STAFF REPORT: 11/13/2024 MEETING (REVISED 11/12/20224) PREPARED BY: J. ROSS
ADDRESS: 1118 SEYBURN
APPLICATION NO: HDC2024-00593
HISTORIC DISTRICT: WEST VILLAGE
APPLICANT/OWNER: JULIE PINCUS
DATE OF STAFF SITE VISIT: 10/16/2024
DATE OF PROVISIONALLY COMPLETE APPLICATION:10/15/2024

SCOPE: INSTALL WOOD SIDING AT REAR ELEVATION AND REBUILD FRONT PORCH

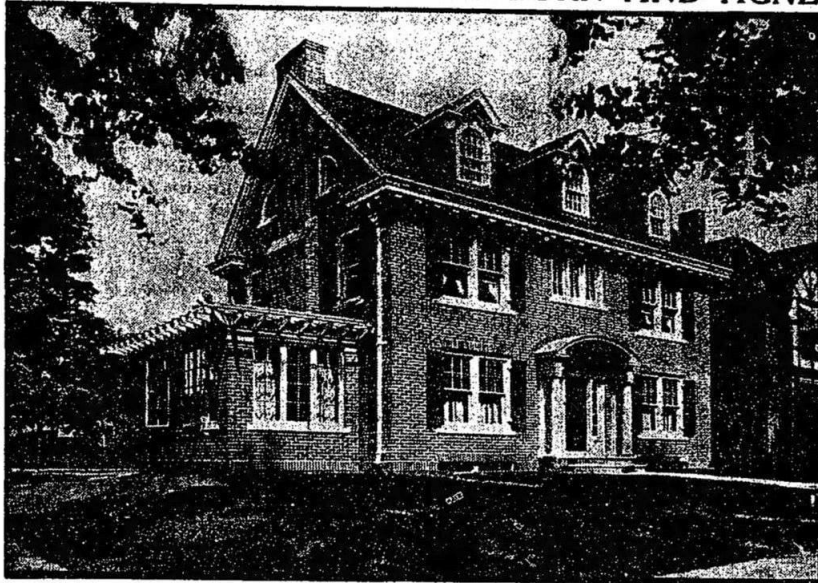
Current condition at rear wall, staff photo taken on 10/16/2024. Area outlined in red indicates proposed location for lapped wood siding.

Sanborn Fire Insurance Map, 1915. Note that the property's address was 254 Seyburn in 1915. Also a masonry/brick veneer was found at all four sides of the house's main body.

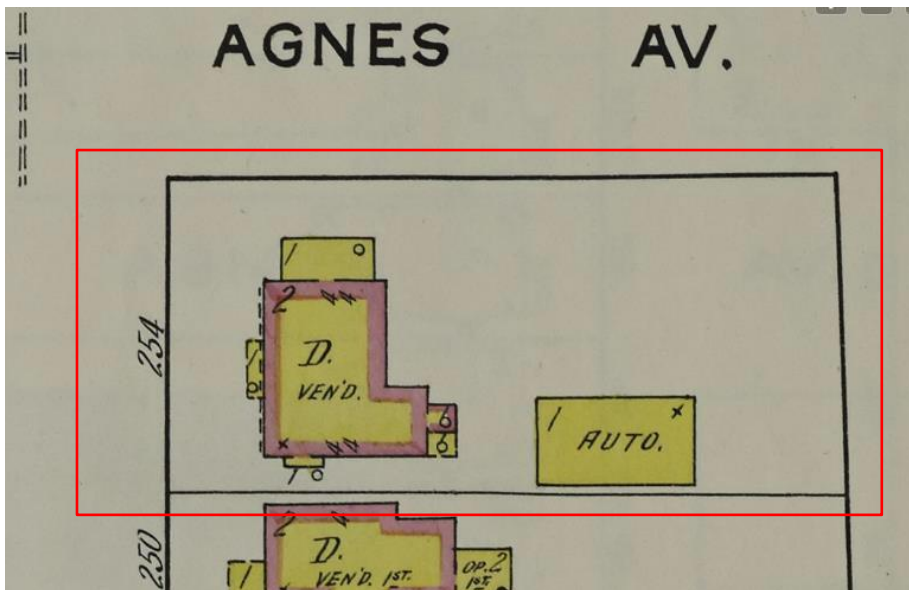
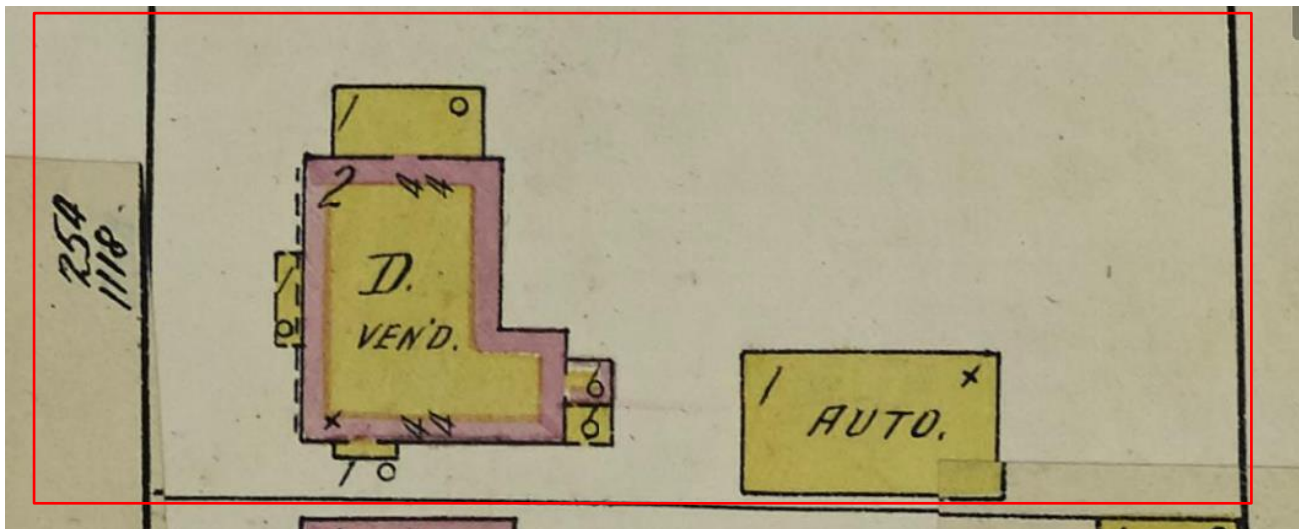
- Per the above Sanborn Maps and the 1915 Detroit Free Press article, the building originally had brick at all four walls as it is *typical* that a house of this vintage would display a single cladding material at its main body, while a secondary material might be located at a subordinate side or rear wing, addition, gable end, chimney, or projecting bay. As such, brick of the same appearance as the existing brick at the front and side walls would be the *most appropriate* material for installation at the building’s rear wall.
